Re: Completion of the Canadian Zinc Environmental Assessment (EA)

**Canadian Zinc's Responses to Questions Raised by Responsible Ministers and MVEIRB
(MVEIRB Letter to CZN dated December 24, 2002)**

PRAIRIE CREEK MINE

Figure 3

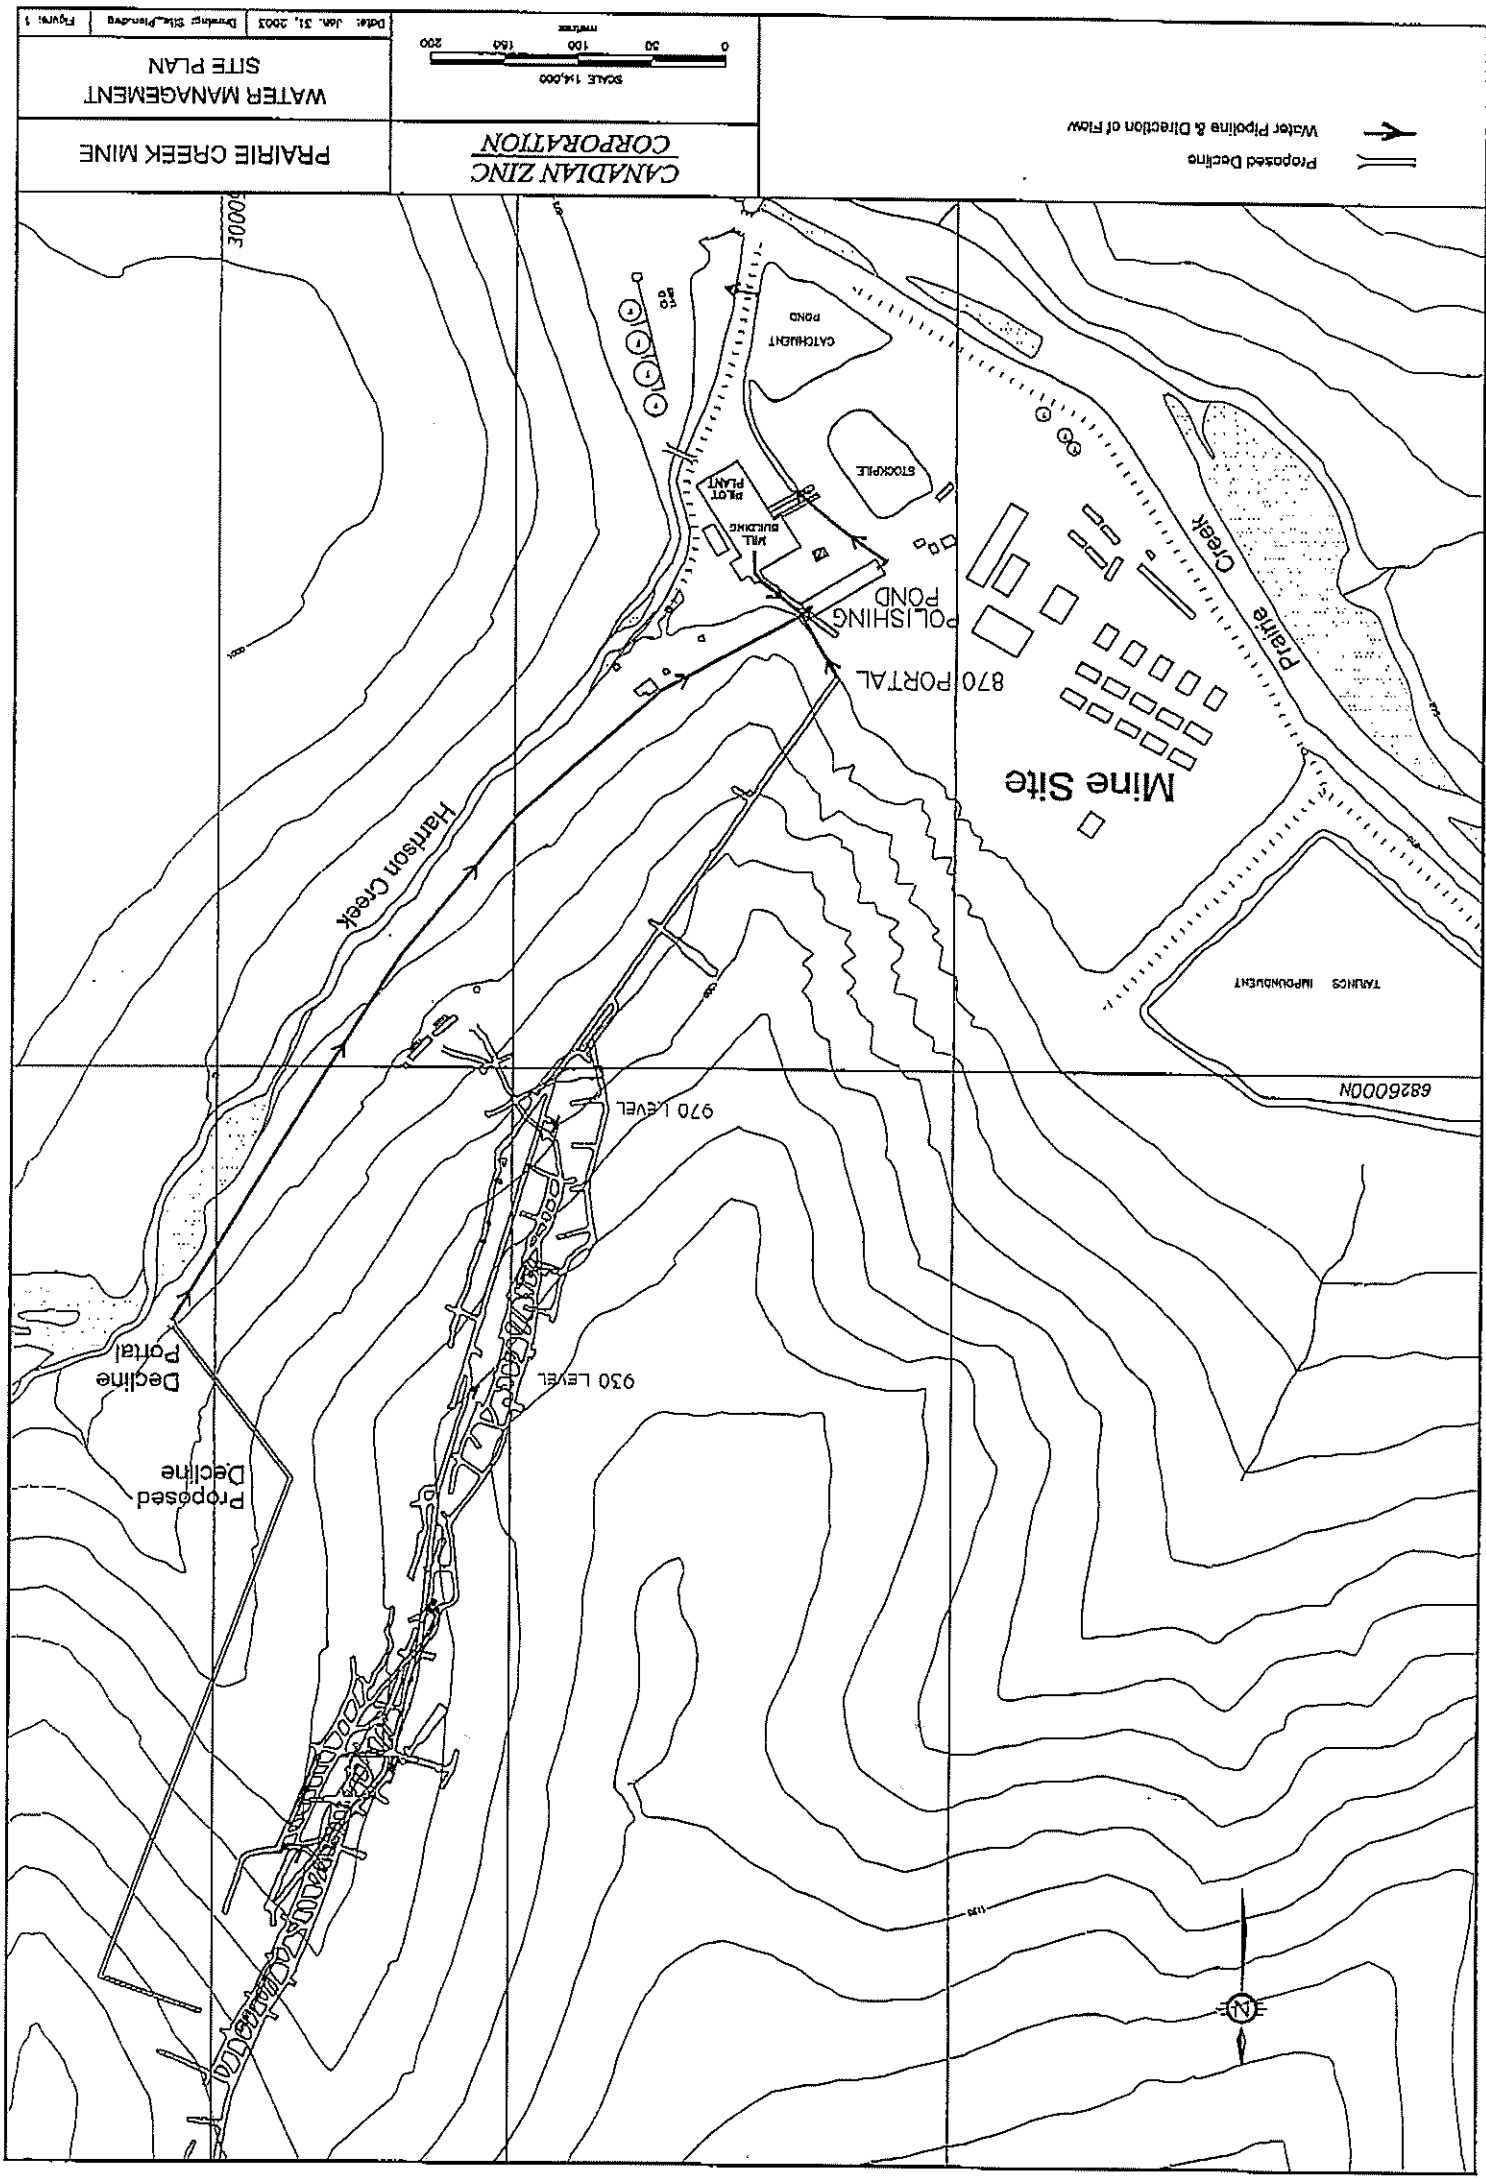
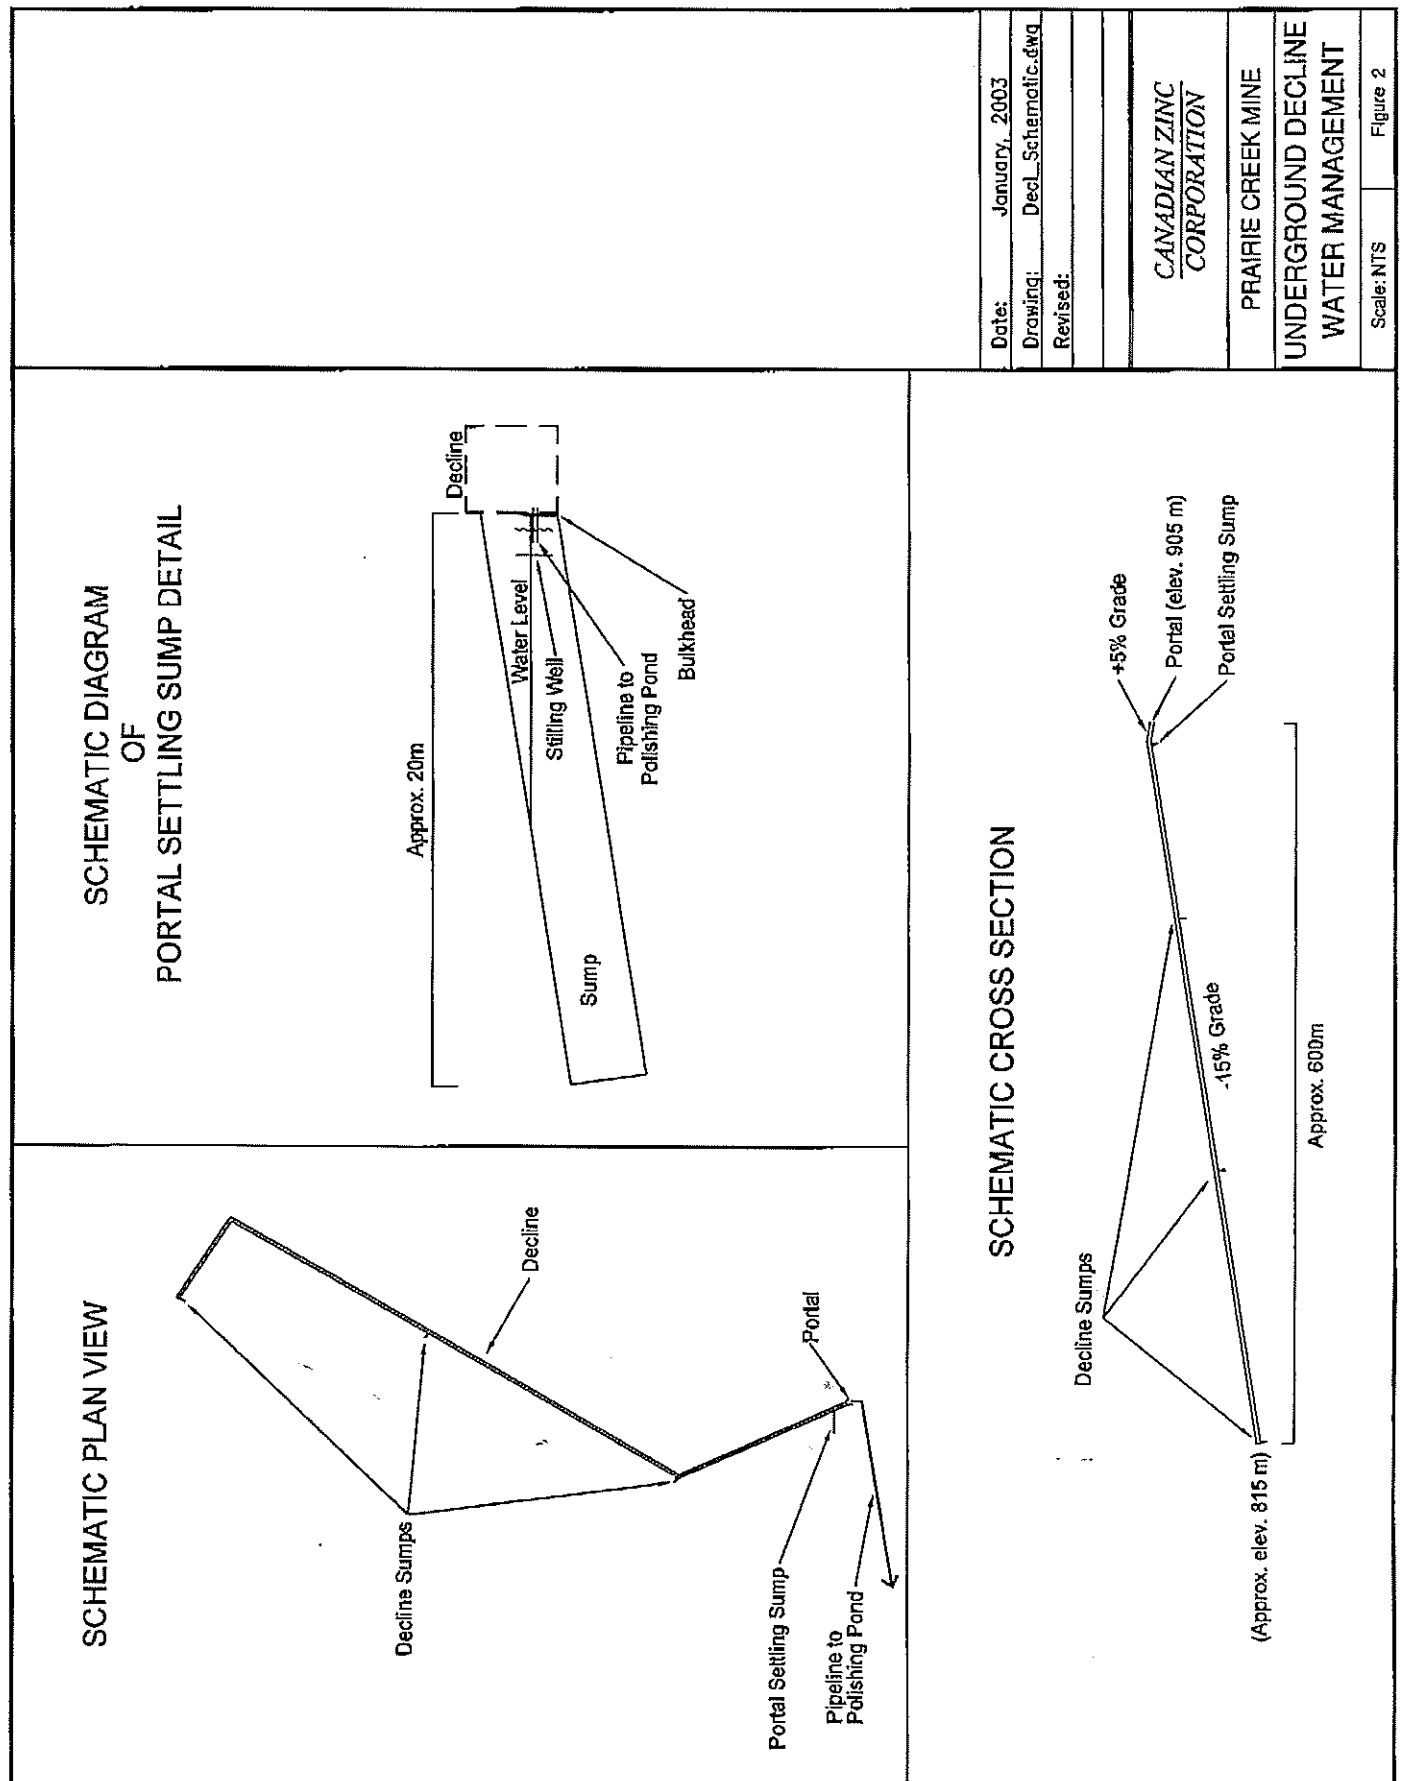
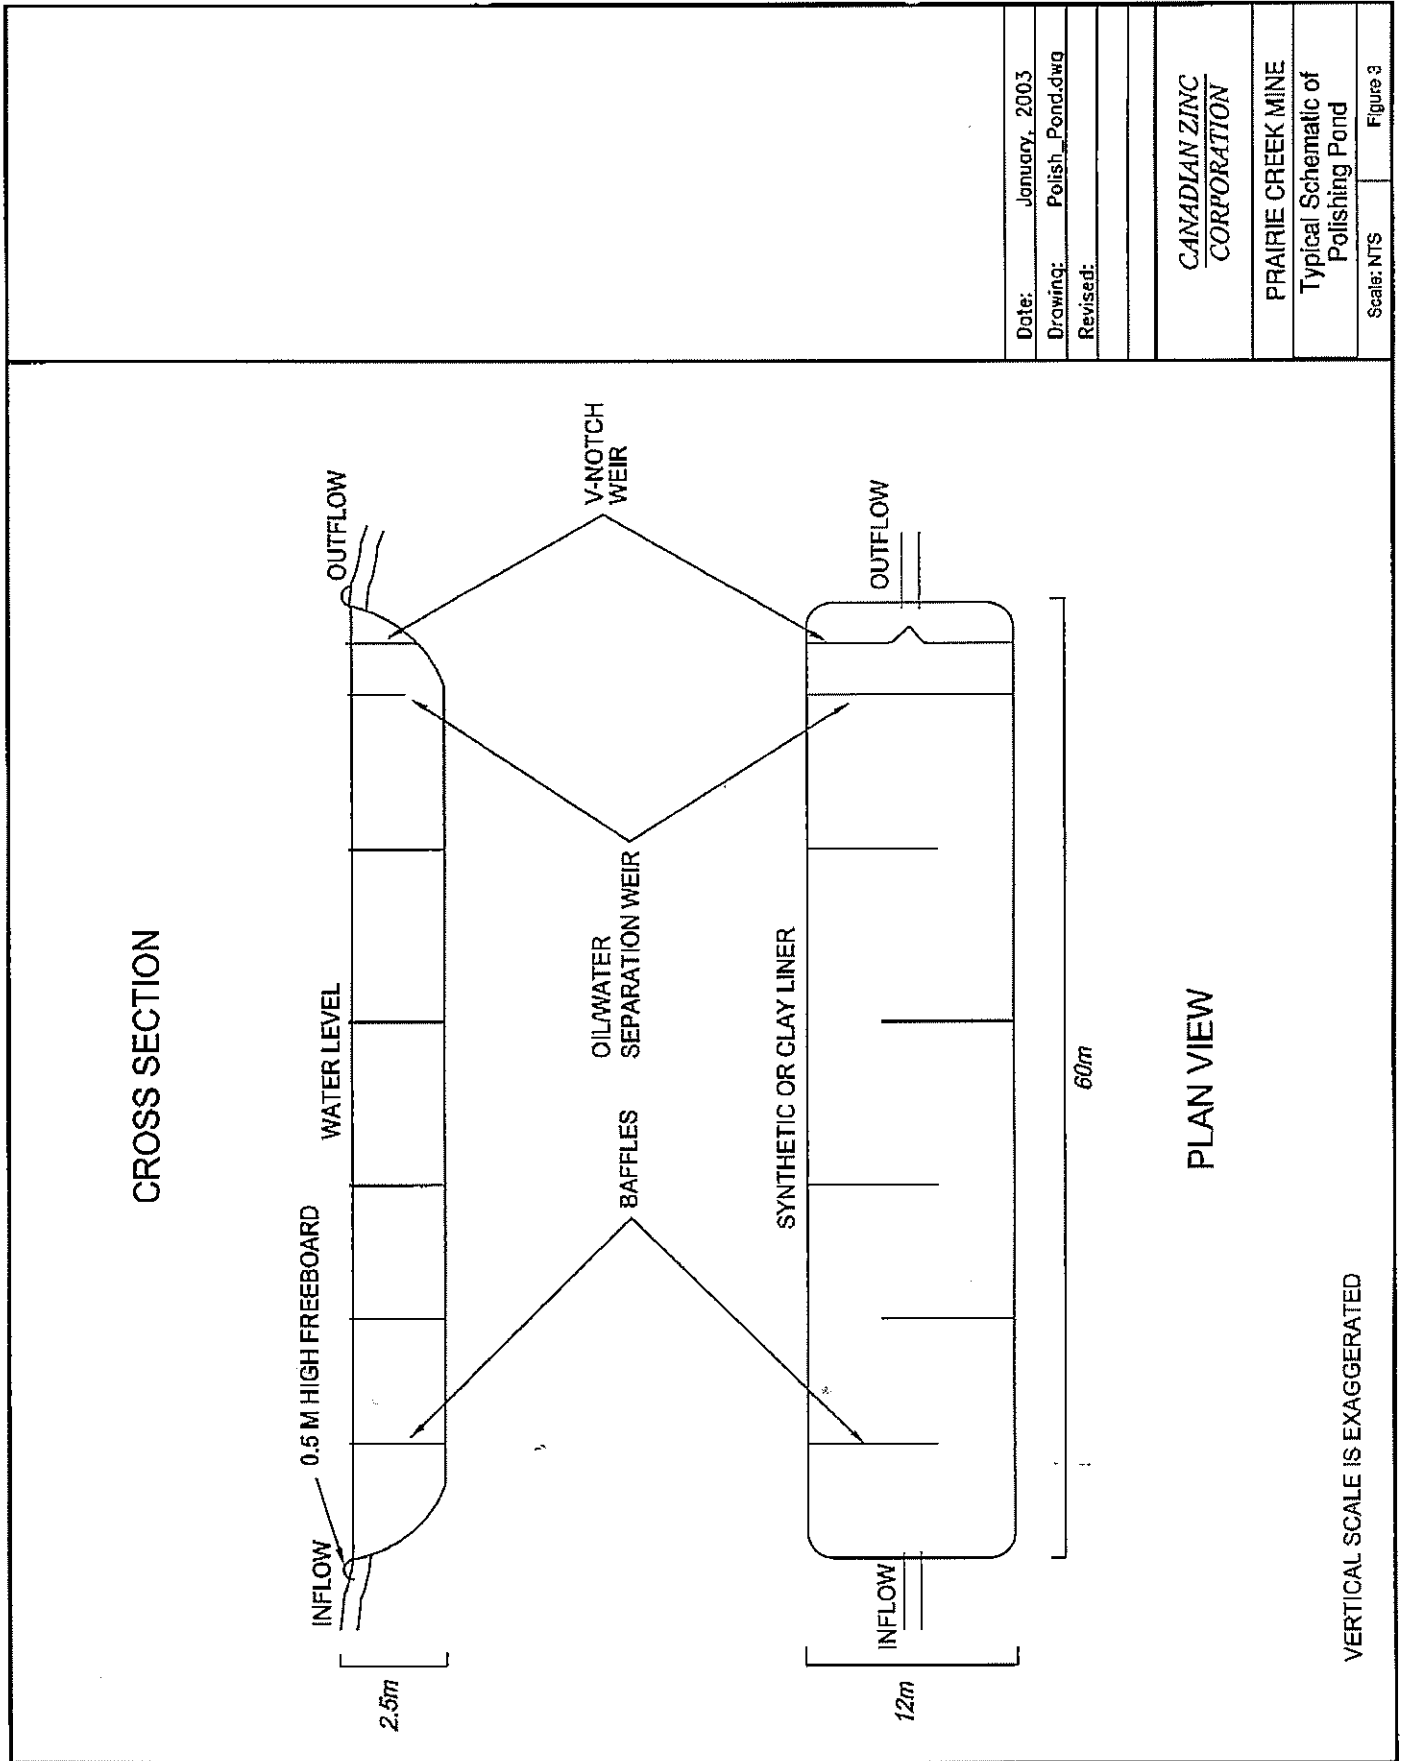
5. *CZN's IR response suggests that minewater could be contained in a proposed polishing/treatment pond constructed adjacent to the mill. Please explain if and how CZN will ensure the proposed polishing/treatment pond is impermeable and appropriately sized for treatment.*

The polishing pond will be sized based on flow volumes reporting to it to allow sufficient retention time to effect settling. Typical criteria for such sizing suggest a pond with a length to width ratio of 5:1 and a retention time of 20 hours¹. The current design for the polishing pond, based on worst case design combined inflows of 0.02m³/s from the decline, 870m portal and pilot plant, and is for a pond 12 m wide by 60 m long by 2.5 m in depth for a volume capacity of 1440 m³ with a 0.5 m freeboard. Sufficient area is available in the proposed location between the mill and the 870 portal to enlarge the polishing pond if necessary to accommodate larger flow or to effect more efficient settling as the case may be.

The polishing pond will be lined either with impermeable clay or a synthetic liner. Impermeable clay is available locally and was used in the original construction of the tailings impoundment. A bentonite mix could also be used as a liner. Synthetic liner is also available on-site from the construction of the tailings pond. Alternatively, new liner may be sourced and flown into the site.

Dissolved metals will be treated in a polishing pond proposed to be located between the mill and the 870 portal at about the 864m elevation. This will permit minewater from both the decline and 870 portal to be directed by gravity through pipes to the polishing pond without the need for pumping. The polishing pond will be excavated into the ground with berms constructed around the pond to prevent inflow of surface runoff. The pond will be lined with clay or a synthetic liner to prevent exfiltration to the groundwater. The polishing pond is proposed to be 12m wide by 60m long by 2.5 m deep providing a capacity of 1440 m³ with a 0.5m freeboard. This in turn would provide an additional 20 hour retention time at the estimated worst case inflow rate of 0.20 m³/sec for the combined discharges from the 905 decline portal, 870 portal and pilot plant. Internal baffles or berms will also be employed to prevent short circuiting and maximize retention times. Provision will also be included for the use of settling aids, such as flocculants, if necessary to facilitate settling of solids and precipitates.

The treatment and polishing ponds will be designed to retain all settled material without resuspension and to provide access in the event that the ponds are required to be cleaned out during operations. Given the short term nature of the proposed developments, it is expected that the ponds will be sized so as not to require cleaning out. Sufficient tankage is available in the mill to retain all tailings material generated during operations of the pilot plant.

Sufficient area is available in the proposed location between the mill and the 870 portal to enlarge the polishing pond if necessary to accommodate larger flow or to effect more efficient settling as the case may be.
